# UNITED STATES PATENT AND TRADEMARK OFFICE

10/559,918

Marko Leinonen

<b>Office Action Summary</b>	<b>Application No.</b> 10/559,918	<b>Applicant(s)</b> LEINONEN ET AL.	
	<b>Examiner</b> HARRY LIU	<b>Art Unit</b> 3662

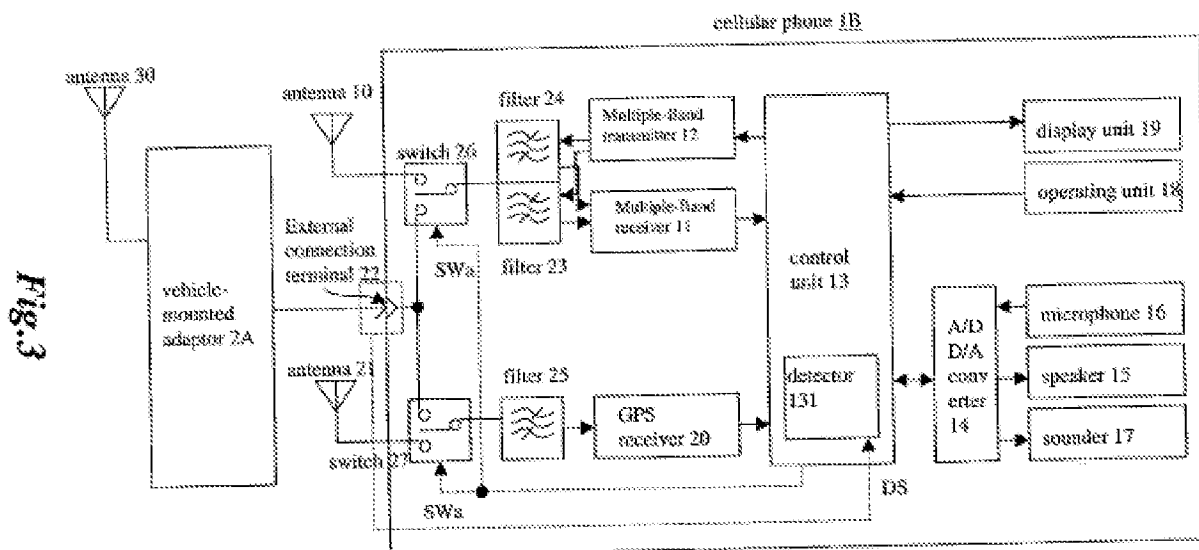
Regarding claims 1, 6, 8-9, 13, 15-19, Yoshida discloses a mobile device with built-in GPS receiver with receiver comprising first and second receiving chain and frequency band; at least a first antenna (shown 2, article 10, 21 in FIG. 3 below) connected to first receiving chain (**cellular** part) switchable (via switcher 26, 27) to second receiving chain (**GPS** section); inherently a tuning portion for shifting frequency response from first frequency band to second band (multiband receiver 11 is capable of

Regarding claims 3, 10, 20, Yoshida discloses the use of second antenna (antenna 21 in FIG. 3 above) for second frequency band.
